# 26 RADIATION

## 26.1 GENERAL

### 26.1.1 RADIOLOGICAL CONSIDERATIONS FOR THE NORTHERN TERRITORY TRANSPORT OPTION

Figure 26.3 Radon concentration with distance from operation

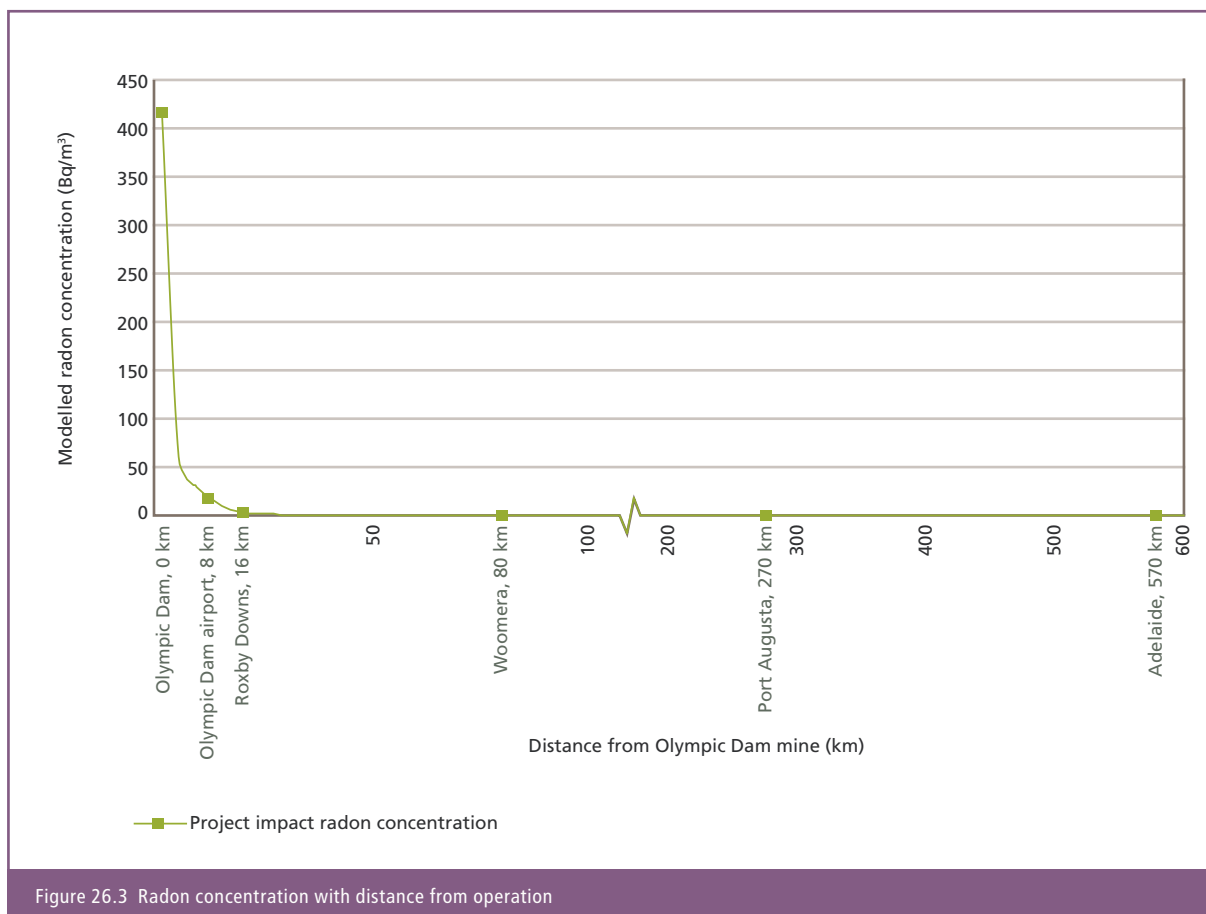
BHP Billiton was asked to specify what radiological issues would be associated with the rock storage facility (RSF) (including seepage and dust lift-off), and to provide a review of radiological impacts when acidic pore water (water filling spaces between grains of sediment) may be formed.

The radon impact modelling was based on the radon source terms provided in Table S6 of Appendix S of the Draft EIS, which is the basis for the modelled radon concentration contours provided in Figure S2.7 of Appendix S of the Draft EIS. This figure showed the impact of the radon emanation from the whole of the operation and also showed the reducing project-sourced concentration at further distances from the RSF.

The impact of the radon from the proposed Olympic Dam expansion should be seen in perspective with the amount of radon that exists naturally in the environment. The conservative modelling of radon from the fully expanded operation, as presented in Appendix S of the Draft EIS in Figure S2.7, showed that for the fully expanded operation, the predicted impact drops off rapidly with distance from the mine. At about 20 km the concentration of radon from the operation is 2.5 Bq/m<sup>3</sup>. This would continue to reduce significantly with distance and is negligible beyond 50 km. Figure 26.3 of the Supplementary EIS shows modelled radon concentrations at distances from the operation. In comparison, the naturally occurring concentration of radon in the region is variable, with the average being approximately 20 to 30 Bq/m<sup>3</sup>.
